TECHNICAL SERVICE BULLETIN

Delivery/Courier Usage Only - Various Supplemental Restraint System (SRS) DTCs

23-2230

Ford
2019-2020 Transit

Figure 1

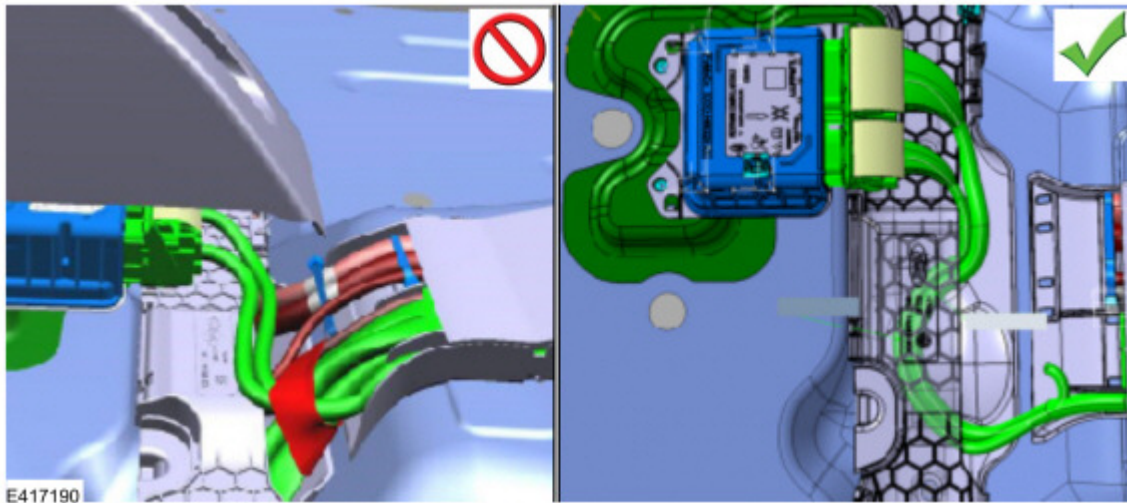
1. Access the RCM and connector C310A and C310B. Refer to Workshop Manual (WSM), Section 501-20B.
2. Inspect the RCM connectors C310A and C310B for any broken hard shell, latches, pins and/or wiring. Is there any damage detected in the connectors?
 - (1). Yes - proceed to Step 3.
 - (2). No - this article does not apply. Refer to WSM for normal diagnostics.
3. Replace the RCM connectors C310A and C310B and/or associated wiring with the wiring harness pigtail.
 - (1). Lengthen the amount of wiring on the wiring harness pigtail to reroute the harness and prevent a recurrence of the issue when a user crosses or steps on the RCM location. (Figure 1) Do not shorten the wiring harness pigtail.
